Staff Report

**REQUEST BY DEERY BROTHERS
FOR DESIGNATION OF PROPERTY AS URBAN REVITALIZATION AREA
AND SETTING PUBLIC HEARING**

September 11, 2012

PROJECT NO.
5174-12A
 SHEET
C3.0

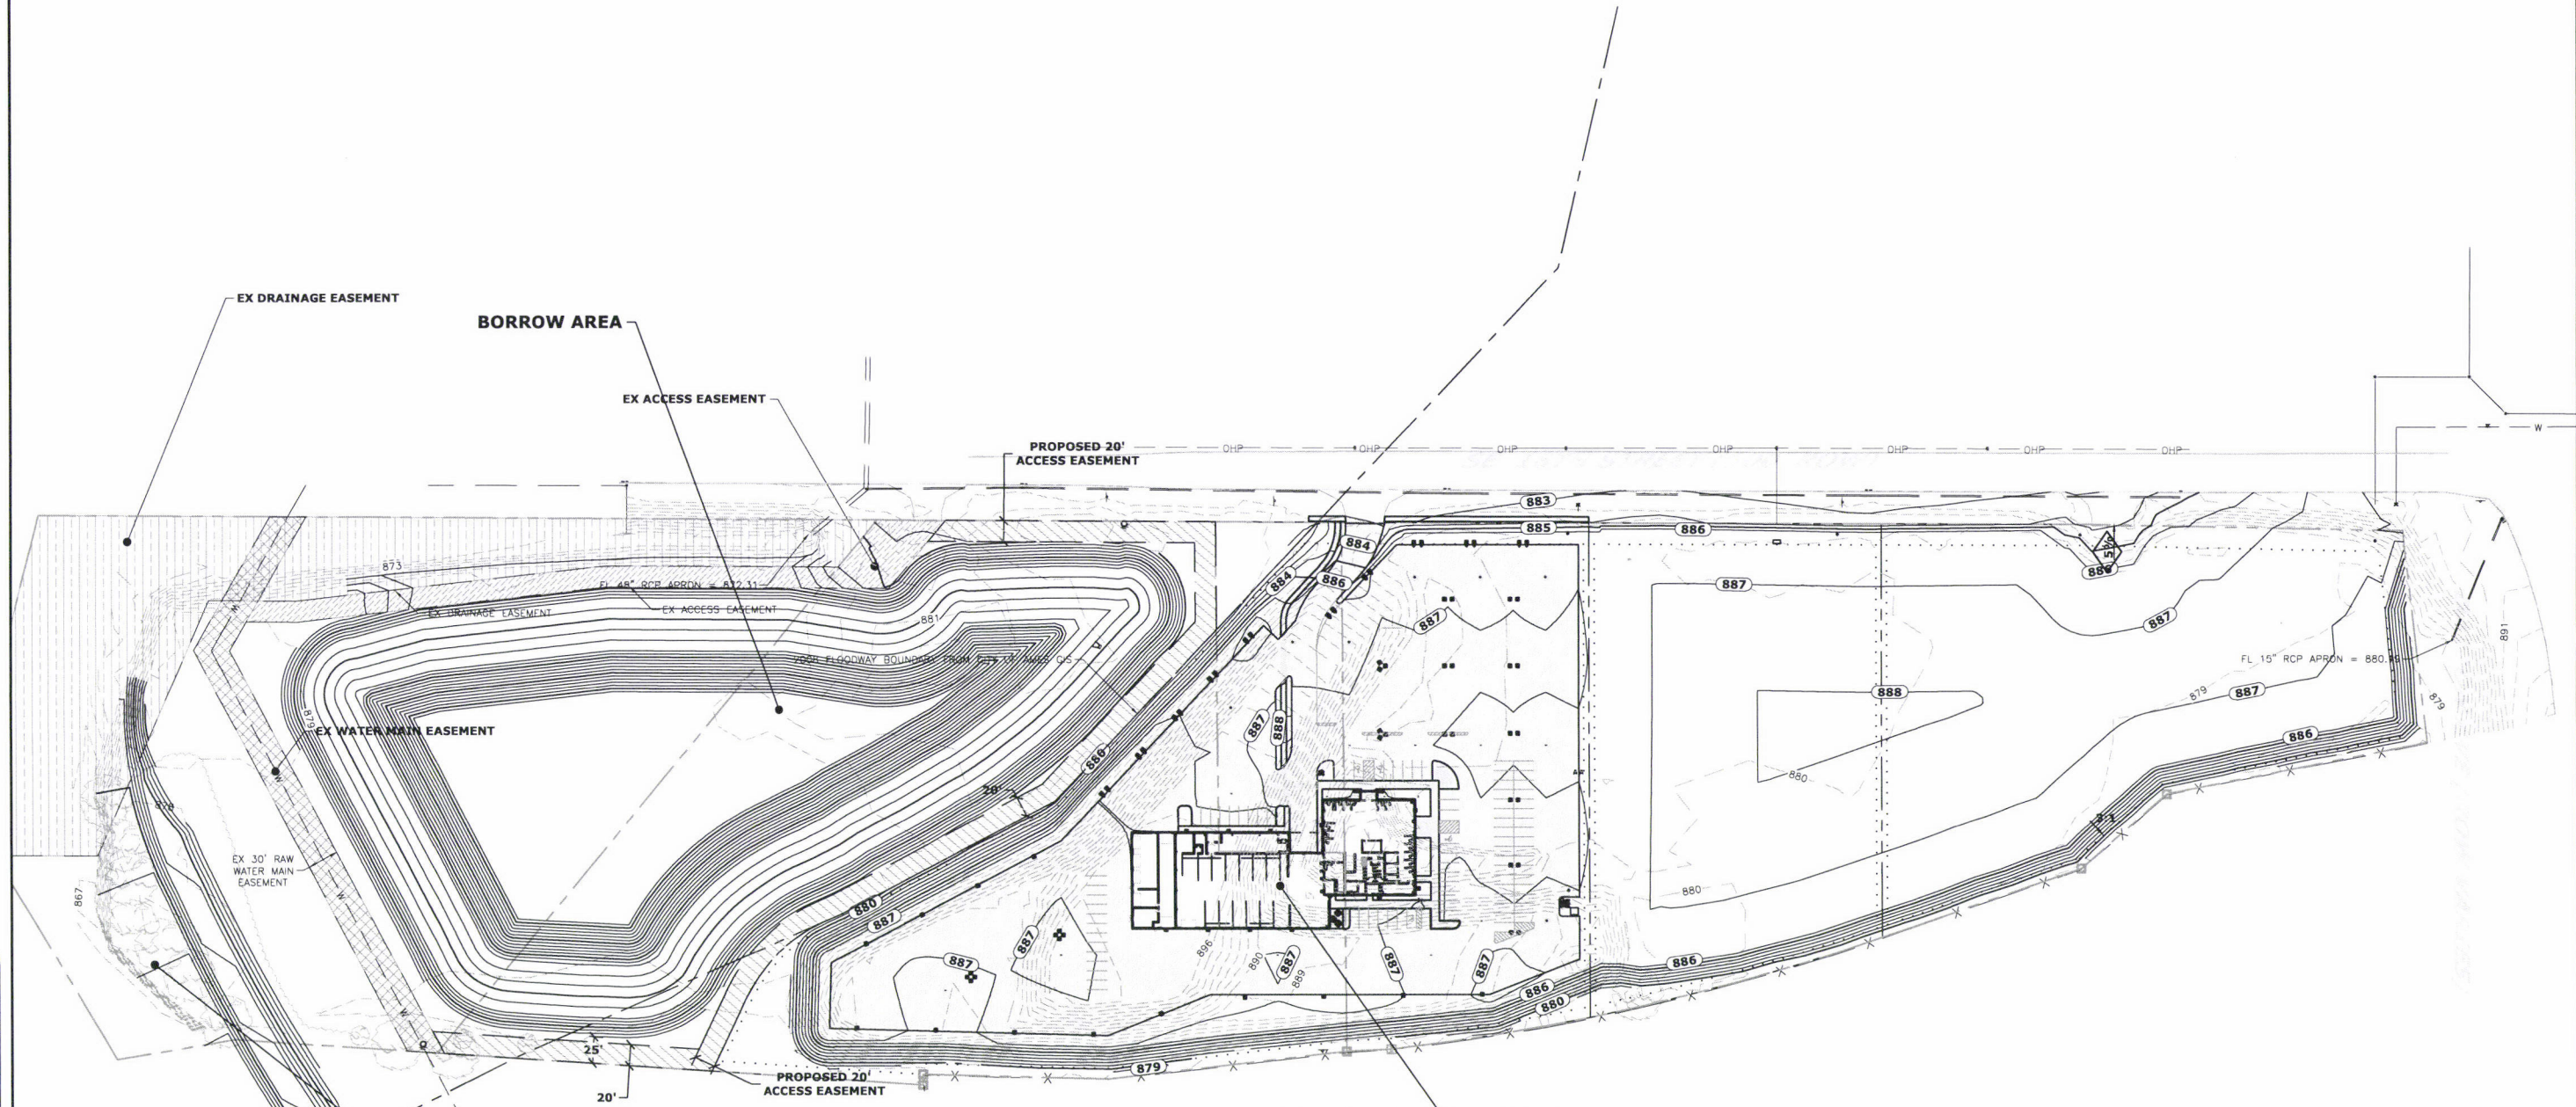
Staff Comments. The proposed site plan indicates that the finished floor elevation of the Deery Brothers building will be at 888 NGVD 29 (Attachment II, Sheet C3.0). The engineer for the project has provided a letter certifying that the proposed improvements (the fill being placed on the site, the excavation within the Floodway, and channel straightening) will result in “no-rise” to the Base Flood Elevation (Attachment I, Pages 7-10). Calculations submitted with the no-rise certificate indicate that although there would be up to 0.08 increase in the 100 year water surface elevation (WSEL) resulting from the fill alone, the river channel repairs (required under Criteria 6 below) in combination with the fill will result in a 0.05 decrease in the WSEL.

The building elevation will be reviewed when the applicant submits an application for a Flood Plain Development Permit prior to construction. **Ultimately, the required elevation will need to be confirmed when the applicant submits an Elevation Certificate prior to occupancy of the building indicating that the lowest finished floor is no less than 887.0 NGVD29.**

Staff Comments The applicant has submitted a grading plan for the straightening of the upper banks of the Skunk River on the east bank adjacent to their property (Attachment II, Sheets C3.0 and C3.2). The straightening creates a 3-to-1 slope adjacent to the top of the normal flow of the river, a 20-foot wide bench, and a 4-to-1 slope up to existing grade. The intent is that, when the river waters rise during a flood event, at a certain elevation these waters will be able to take advantage of the wider cross section of the river and move a shorter distance to go under the bridges at US Highway 30.

SHEET
C3.2

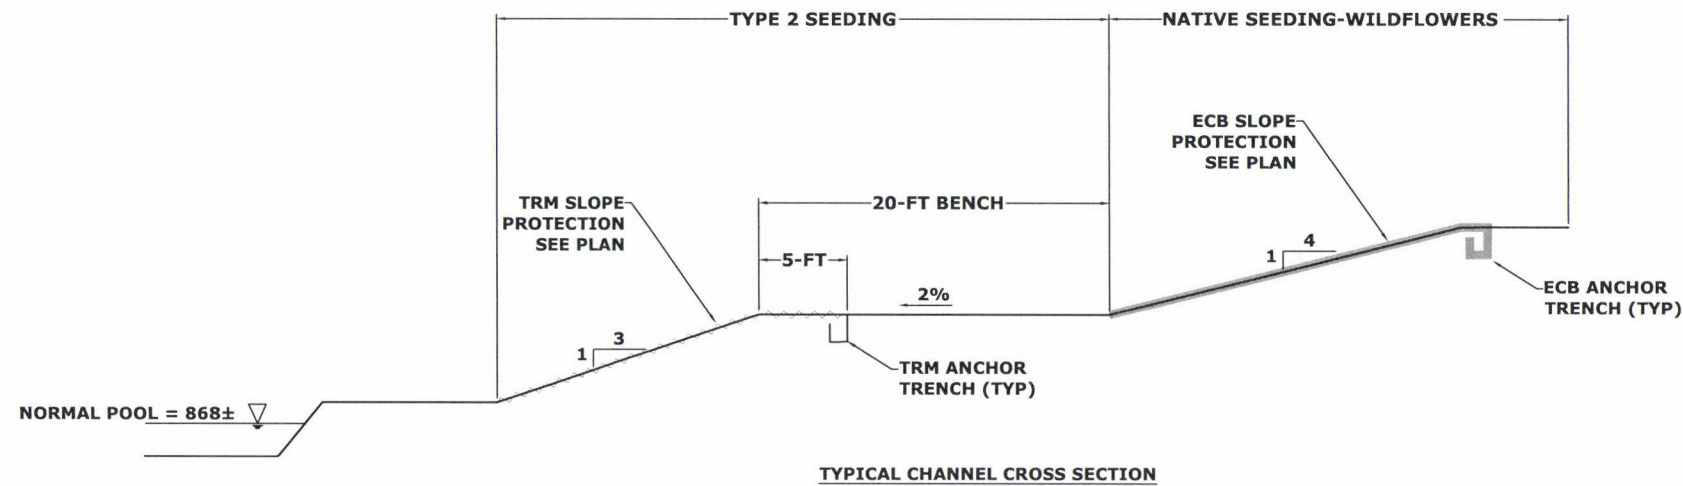
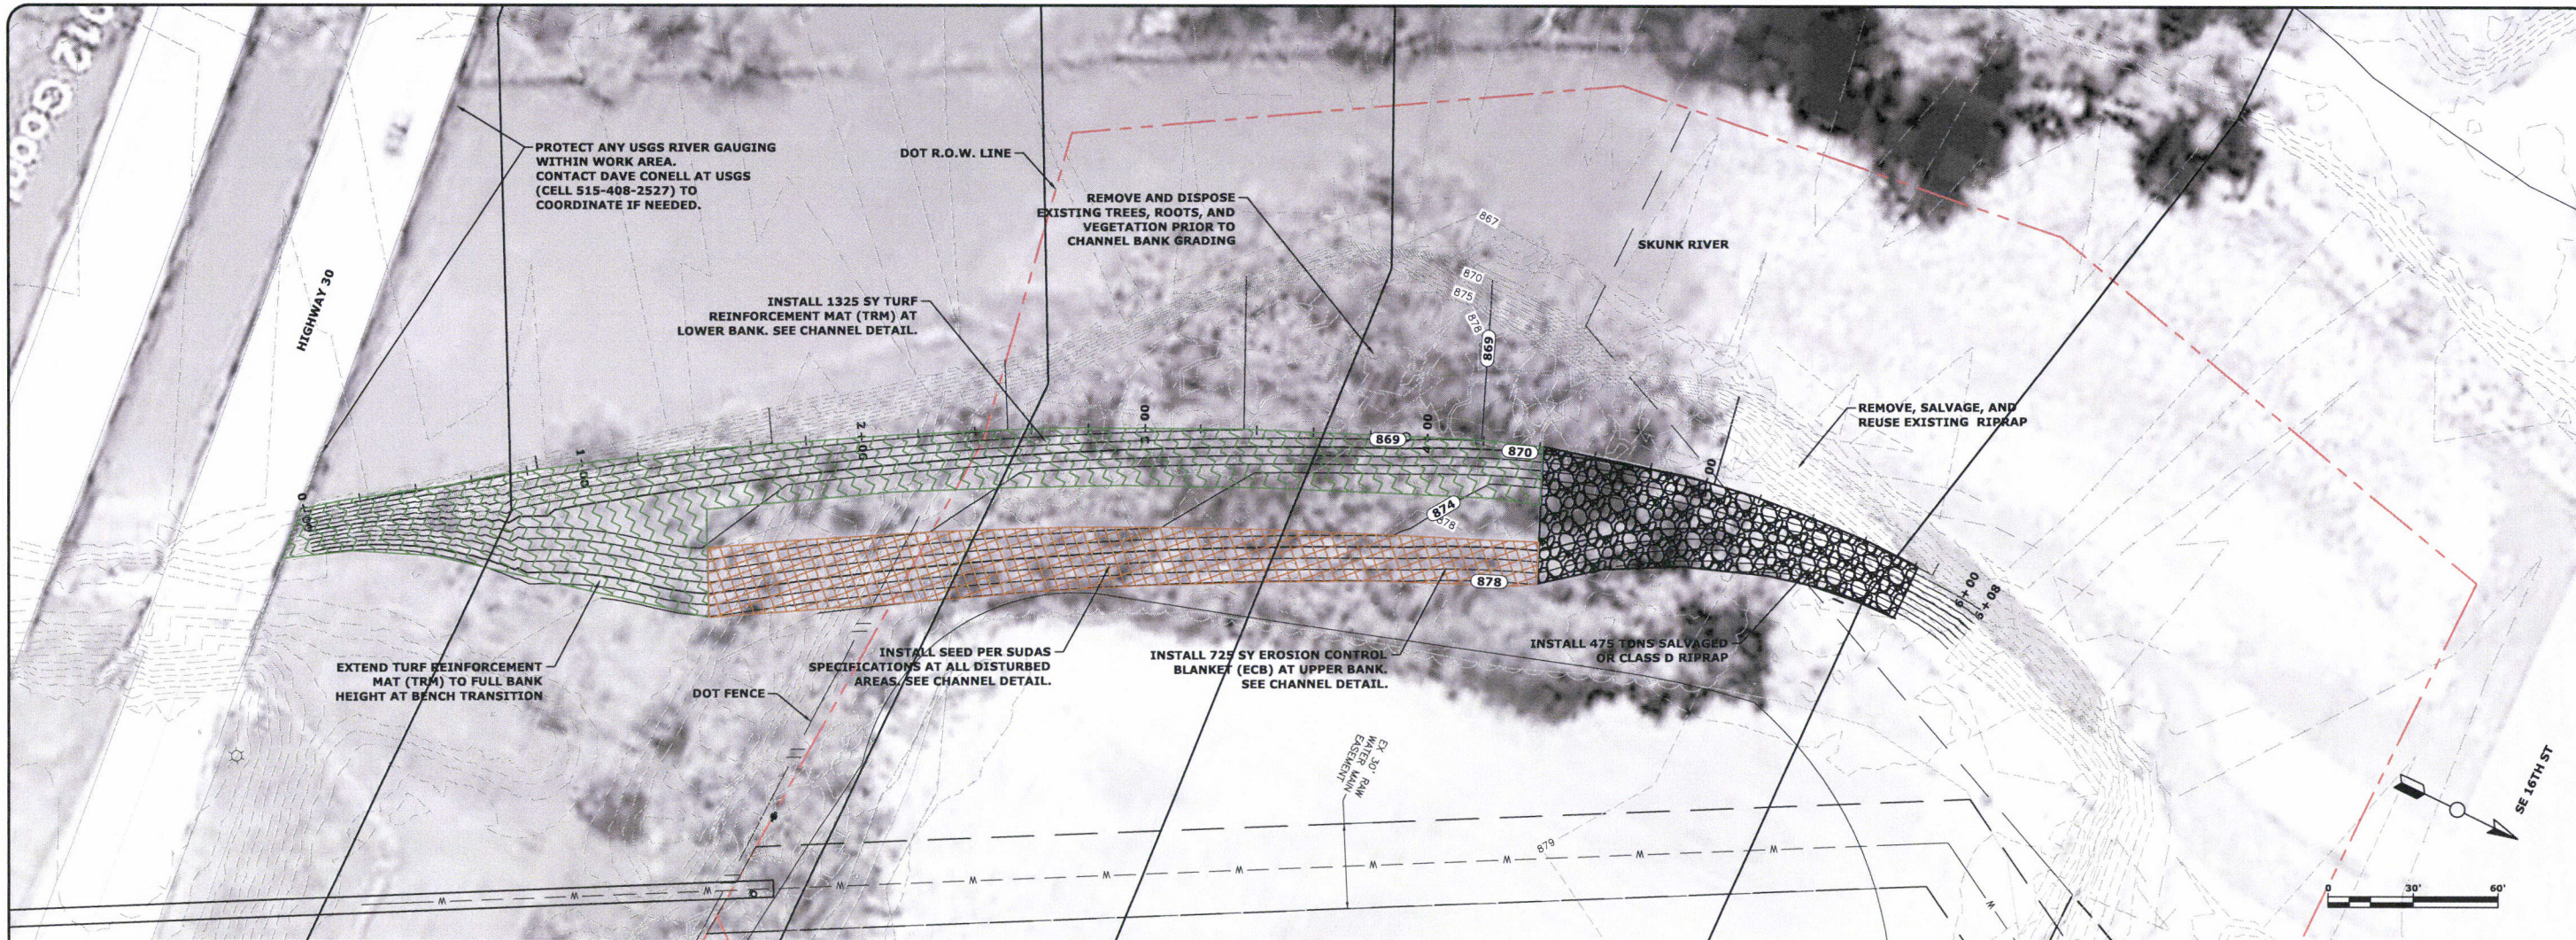
It should be noted that the Urban Revitalization Policy does not provide a definition of ‘mitigate.’ The engineer states in his certification letter (Attachment I, Page 7) that the “project will mitigate flooding by providing an improved and stabilized channel in addition to the no-rise condition.” He further states that “the channel improvements will remove large trees that are in imminent danger of falling into the river during the next major flood event. These trees will potentially lodge in the downstream Highway 30 bridge and create blockages that will catch debris and severely restrict water flow through the bridge.” Finally, calculations submitted with the no-rise certificate indicate that although there would be up to

The City Council should consider (a) whether the reduction of the Base Flood Elevation discharge by between 0.00 feet and 0.05 feet as a result of the channel project meets the Council's expectations to "mitigate flooding" as required under Criterion 6, and (b) whether compliance with the "no-rise" requirement under Criterion 2 can also satisfy the requirement to "mitigate flooding" under Criterion 6.
